Applicant: VALLEY CHURCH
Request: BUILDING PERMIT
Meeting Date: 5/10/2021

Address: 11012 Hardin Valley Rd.
Map/Parcel Number: 103 11102
Location: Southeast quadrant of intersection of Hardin Valley Road and Award Winning Way
Existing Zoning: OB (Office, Medical, and Related Services) / TO (Technology Overlay) and PR (Planned Residential) / TO (Technology Overlay)
Proposed Zoning: N/A
Existing Land Use: Undeveloped land
Proposed Land Use: Church
Appx. Size of Tract: 20 acres
Accessibility: Access is off of Hardin Valley Road, a minor arterial with a pavement width of 42.2 ft inside a 88-ft right-of-way.
Surrounding Zoning and Land Uses: North: PR (Planned Residential) with up to 3 du/ac / TO (Technology Overlay) -
South: RA (Low Density Residential) / TO (Technology Overlay) -
East: BP (Business and Technology Park) / TO (Technology Overlay) -
West: PR (Planned Residential) / TO (Technology Overlay) -

**5-B-21-TOB
CERTIFICATE OF APPROPRIATENESS**

Purpose of Request: Building Permit - New Construction

1	Building Elevation 1 1/8" = 1'-0"
---	---

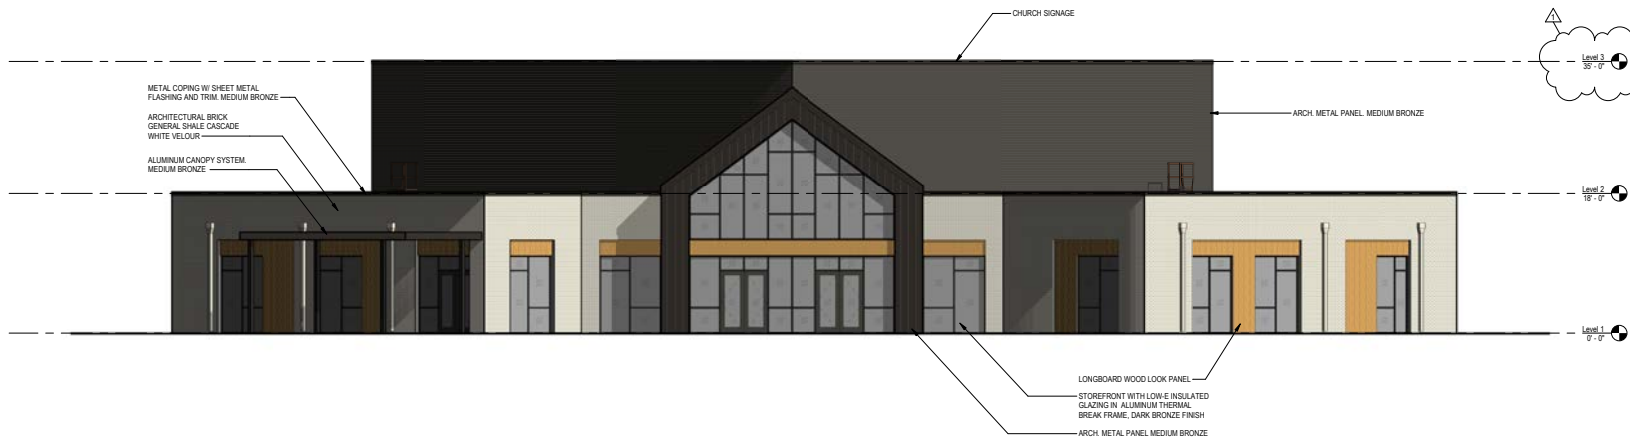
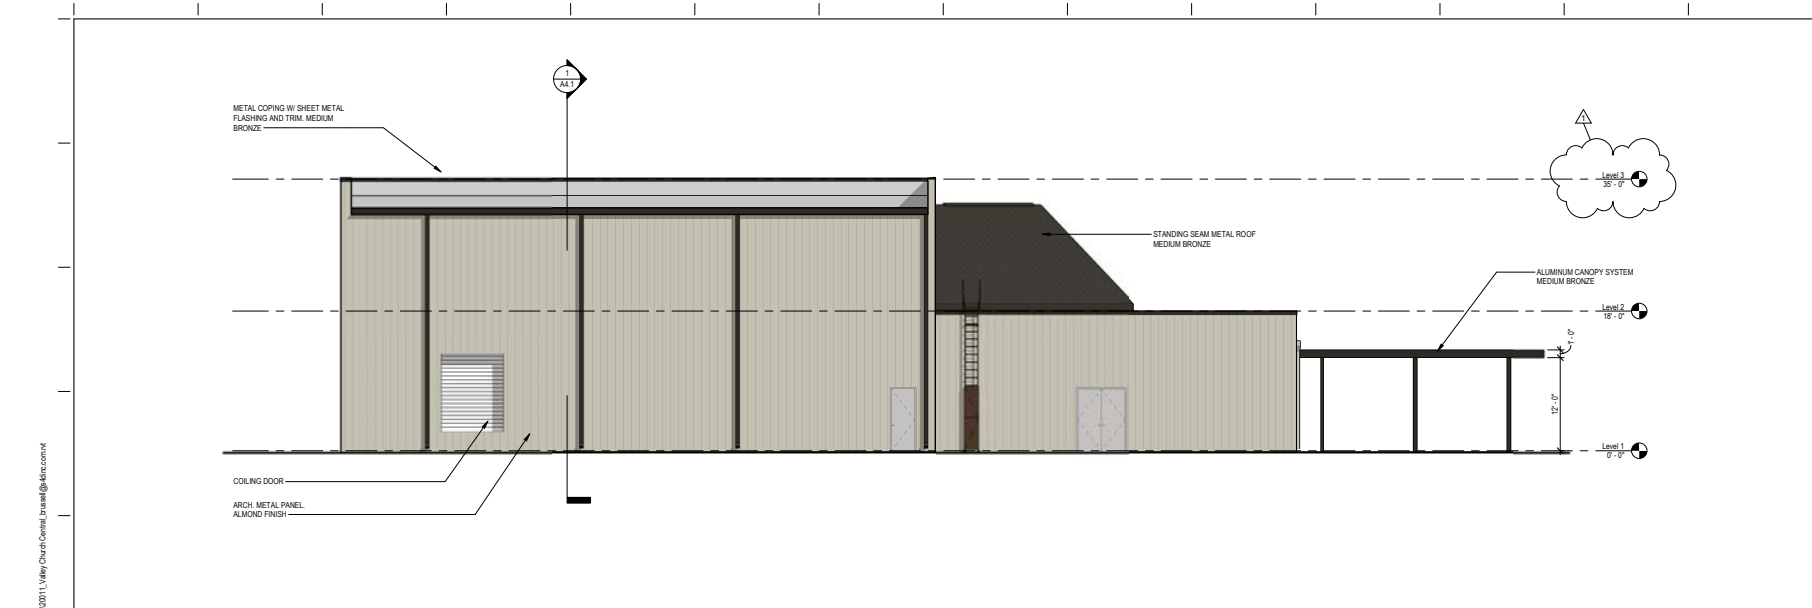
- 10) The proposed structure is 35 ft tall, which meets TTCDA Guidelines.
- 11) The building will feature brick, wood panels, and decorative metal panels. The roof system is a combination of flat roofs and pitched roofs; the pitched roofs will have standing seam metal. Windows will have a bronze glaze. An aluminum canopy system provides shelter from the elements at the entry doors.

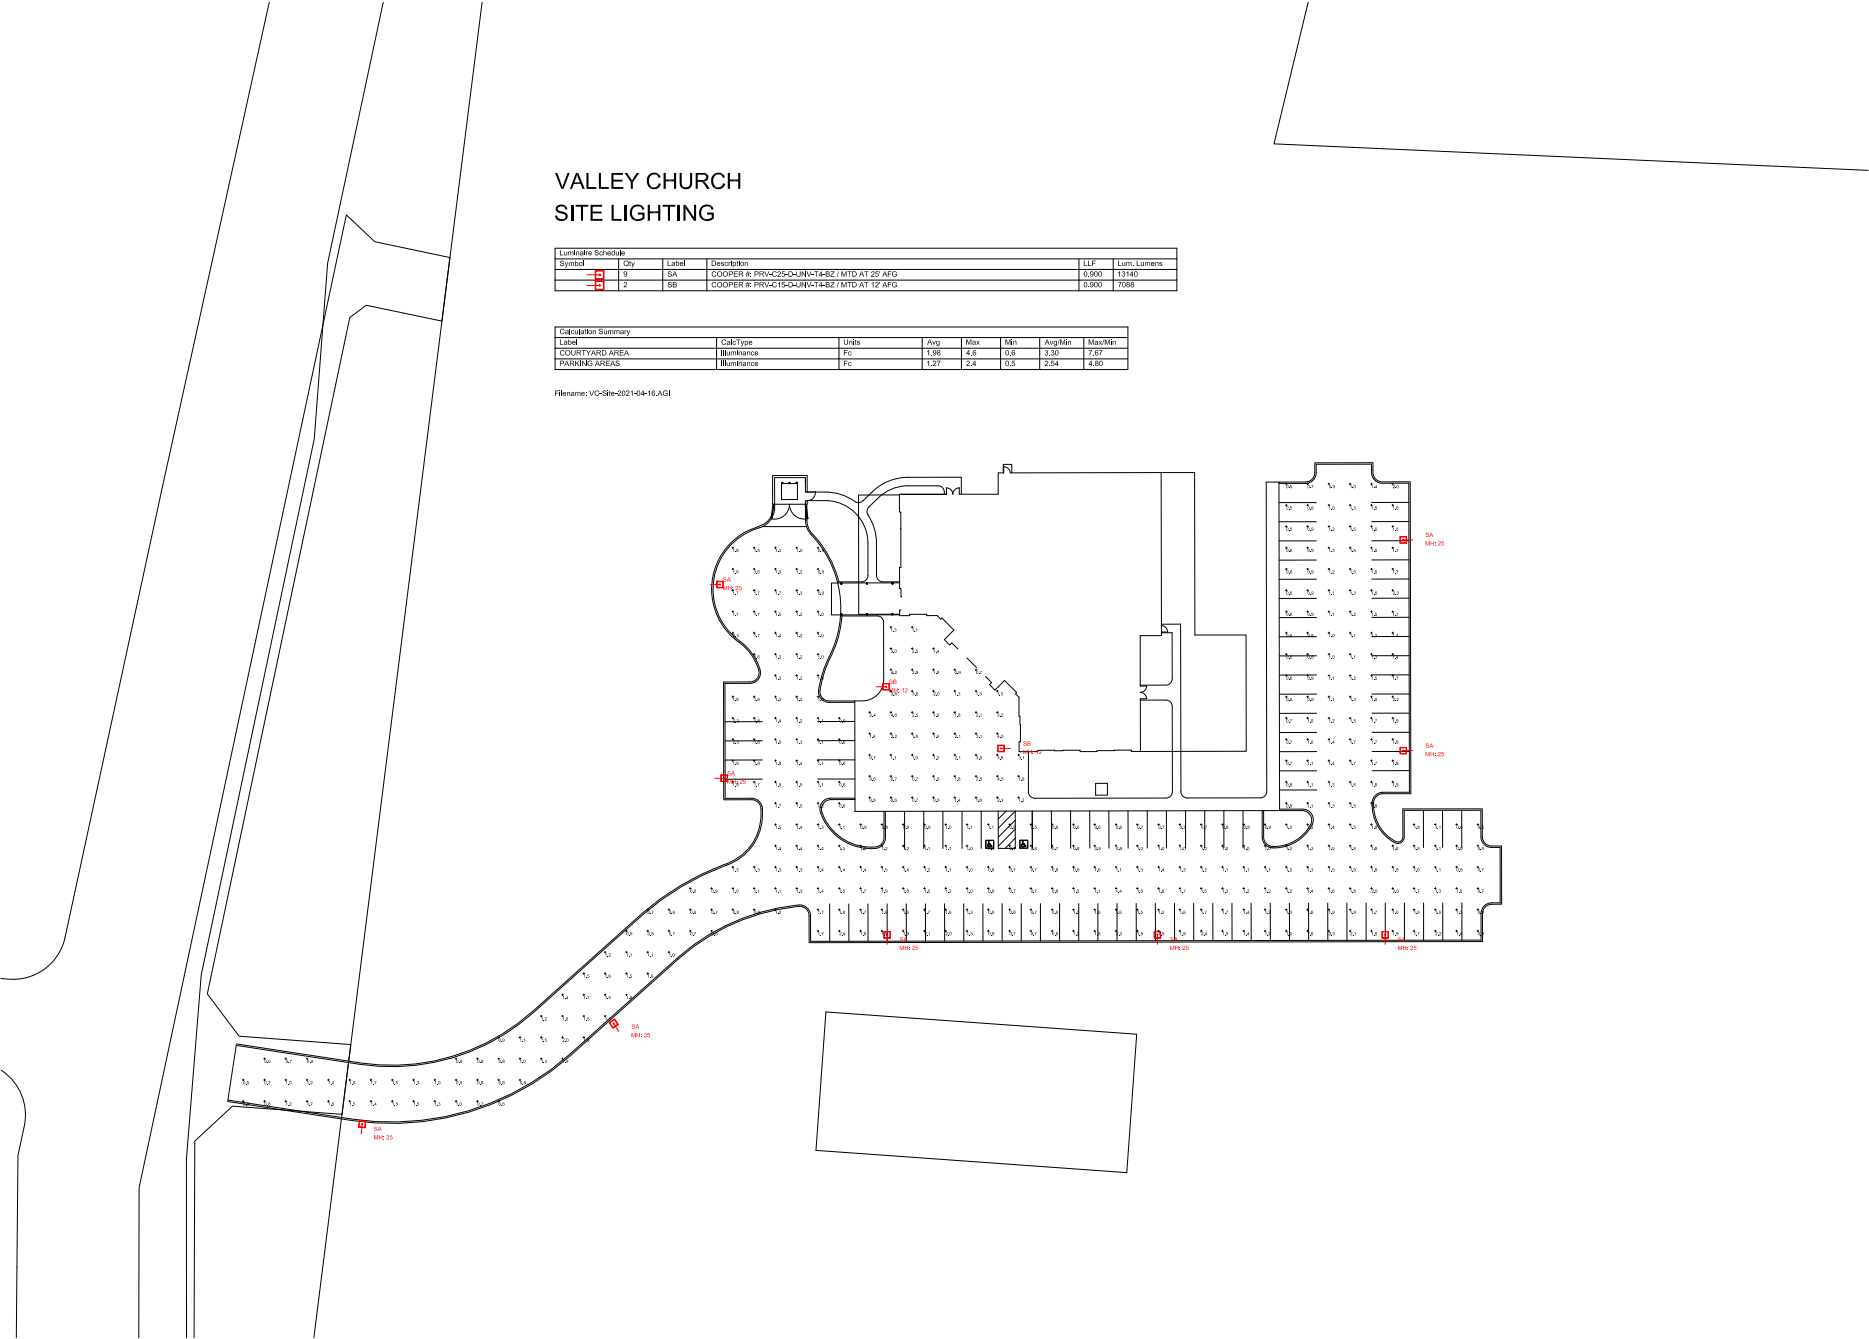
- 8) The proposed landscaping is in compliance with TTCDA Guidelines.
- 9) The proposed lighting plan includes full cut-off LED fixtures for all building and site lighting. Fixtures will be bronze and all light poles specified meet TTCDA height requirements. The proposed lighting complies with TTCDA Guidelines with the exception of the following requested waiver:

- a. A waiver of section 1.8.D to increase the allowable footcandles to 5.5 fc on the entry drive (versus the 0.5 maximum allowed in the Guidelines) to increase safety and security on the site.

Section 1.8.5.D: Increase the maximum intensity of lighting from 0.5 foot candles to 2.0 foot candles along streets and driveways. If approved, this waiver will provide greater illumination along the entrance drive, increasing the safety for those traveling along it.

- 1) APPROVE the waiver to allow 5.5 fc on the entry drive to increase safety and security on the site.
